H. B. ROBINSON STEAM ELECTRIC PLANT UNIT NO. 2  
DOCKET 50-261  
LICENSE NO. DPR-23

REQUEST FOR LICENSE AMENDMENT - REVISION OF TECHNICAL SPECIFICATION

Figure 3.1-1 REACTOR COOLANT SYSTEM HEATUP LIMITATIONS - APPLICABLE FOR PERIODS UP TO 20 EFFECTIVE FULL POWER YEARS

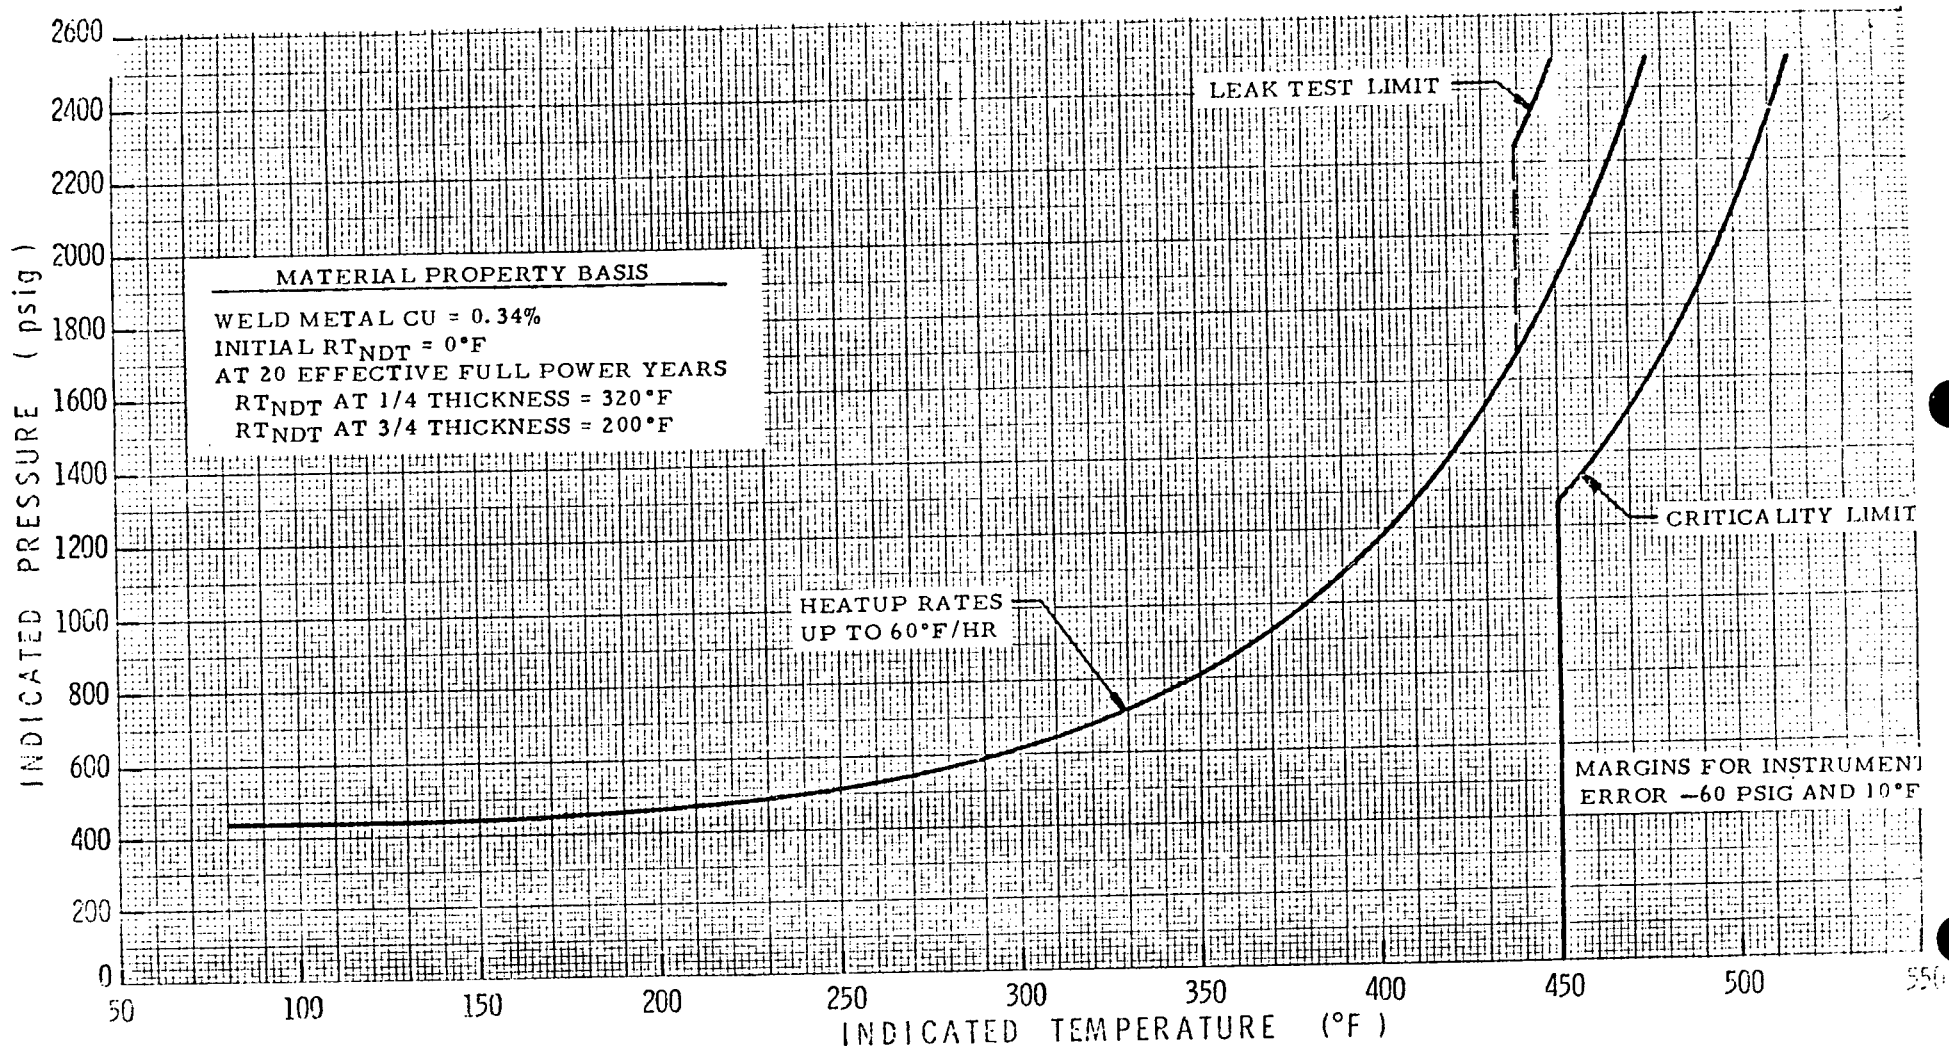
In accordance with the Code of Federal Regulations, Title 10, Part 50.90 and Part 2.101, and Technical Specification 3.1.2.4, Carolina Power & Light Company (CP&L) hereby requests a revision to the Technical Specifications for H. B. Robinson Unit 2. This revision incorporates new heatup and cooldown curves resulting from analysis of samples in the irradiation specimen measurement program.

The revised heatup and cooldown curves derived from this analysis are attached as replacement pages for the unit Technical Specifications. Other replacement pages simplify the bases for this section by deleting some discussion which is merely copied from the referenced reports.

The changes are indicated by vertical lines in the margin of the attached pages. We request your prompt attention to this revision since the applicability of the present heatup and cooldown curves extends only to approximately February 11, 1976.
